# Proposed Changes for Annex 69B

Howard Baumer, Magesh Valliappan

04-Mar-2006

# KX4 vs. CX4 (RL)

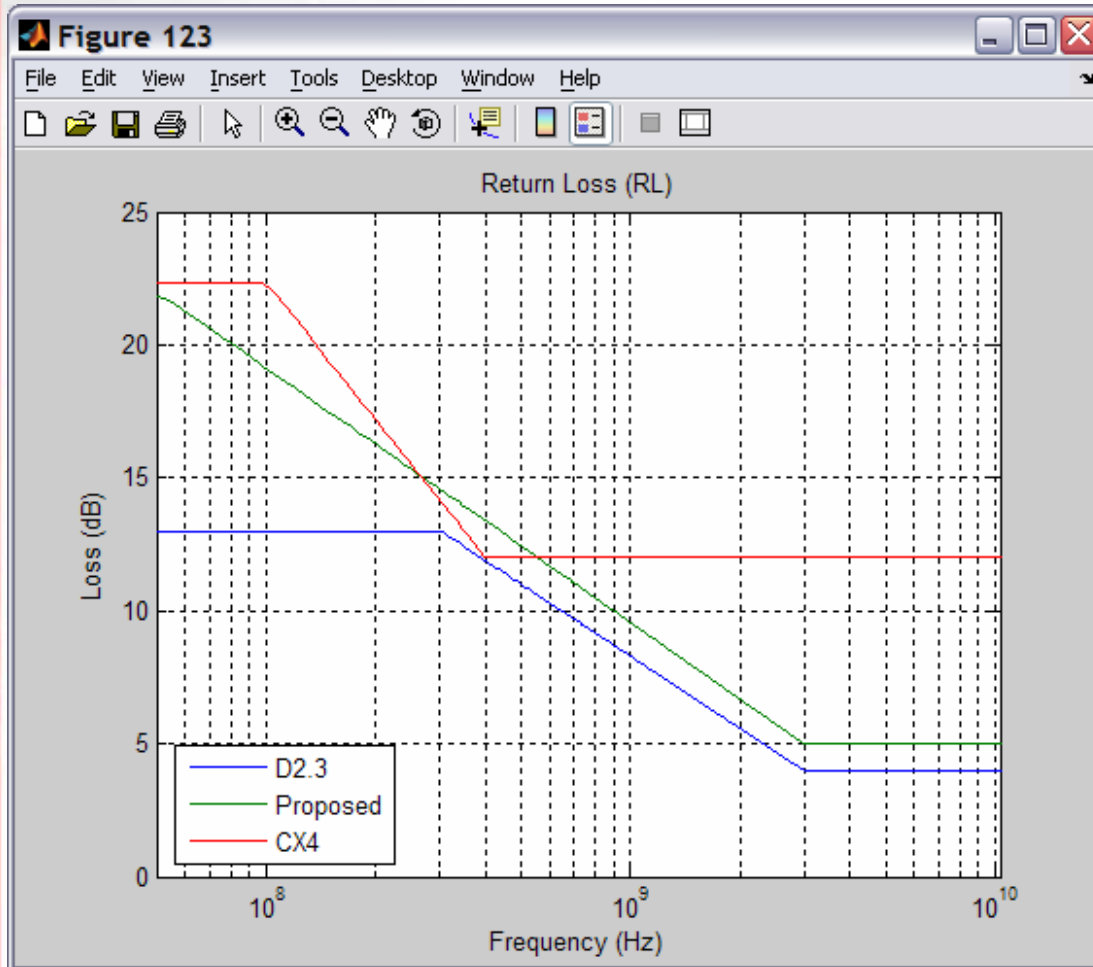
- 10GBASE-CX4 RL less than proposed 10GBASE-KX4 RL in frequency band of interest, 100MHz – 2000MHz

# KX4 vs. CX4 (ICRfit)

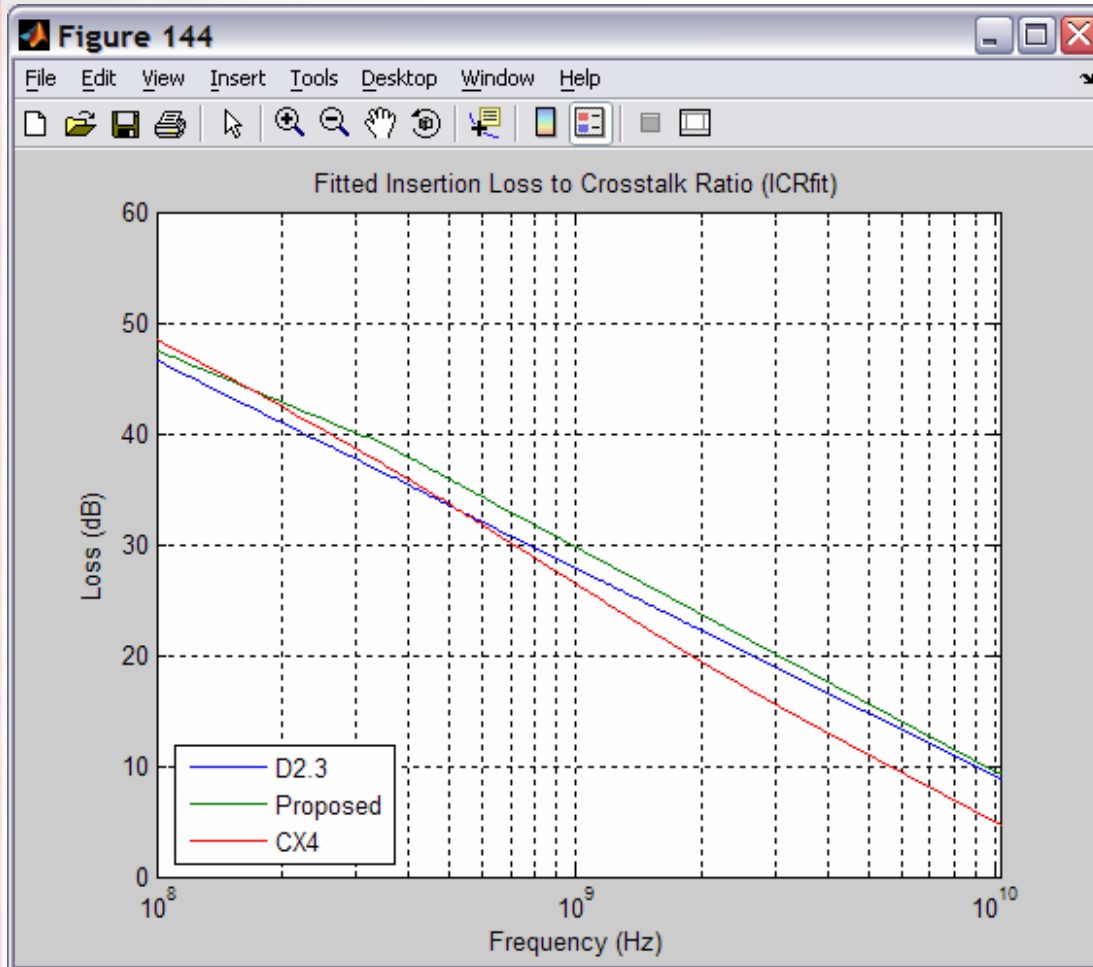
- $ICRfit = IL - MDX$
- 10GBASE-CX4 ICRfit more stringent than proposed 10GBASE-KX4 ICRfit in frequency band of interest, 100MHz – 2000MHz
